JOB TITLE:  
PROPOSED ENGINEERING WORKS  
96 BEACH HAVEN ROAD & 13 CRESTA AVENUE  
BEACH HAVEN

# Drawing RC400 Detailing the Proposed Primary Stormwater Drainage System

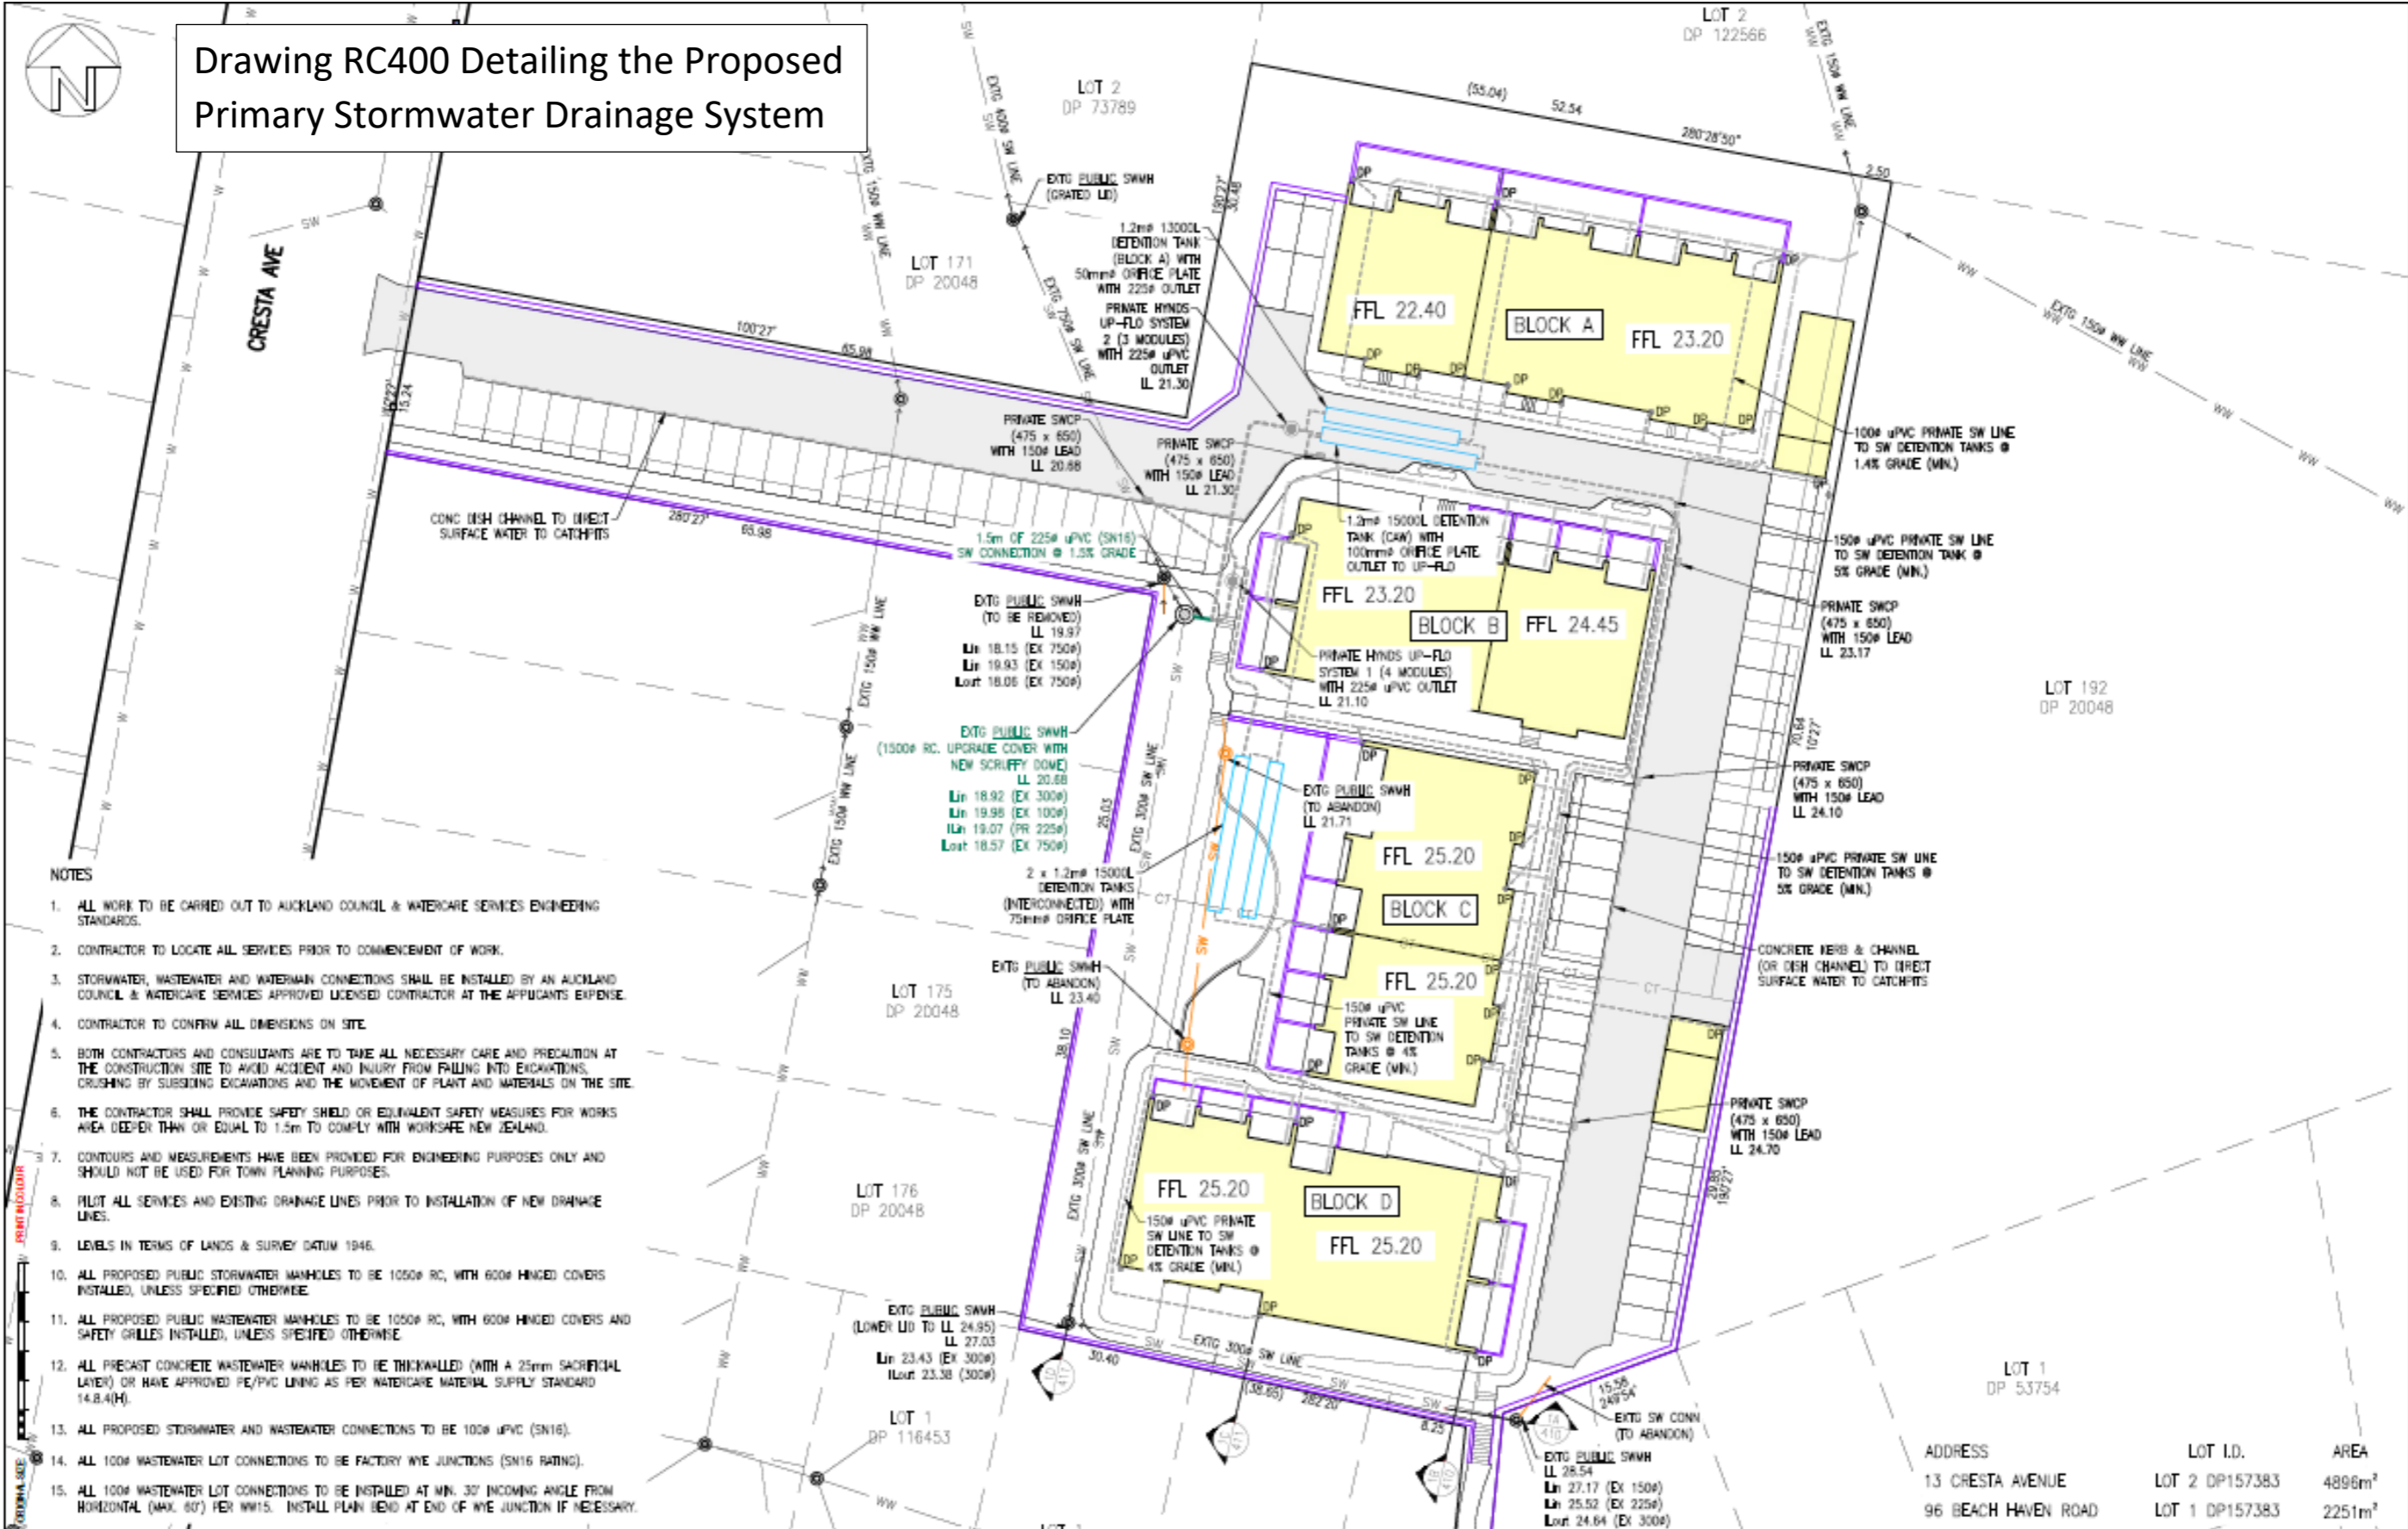
We had a quick look at the HEC-HMS model for detention tank sizing which was provided as part of the Resource Consent application (and subsequently as requested in conjunction with the recommenced PPC process). We noticed that Tank D is possibly undersized. For 10% AEP storm events, the peak storage in the tank is ~25m<sup>3</sup>, while a 15m<sup>3</sup> tank is shown in the model. For 1% AEP storm events, the size of Tank D will be 52 m<sup>3</sup> versus 15m<sup>3</sup> as designed.

We noticed that Tank B and Tank C are in series, and both tanks had orifices at outlets. It is more effective to use a single large tank or remove the orifices on the upstream tank to improve attenuation effects.
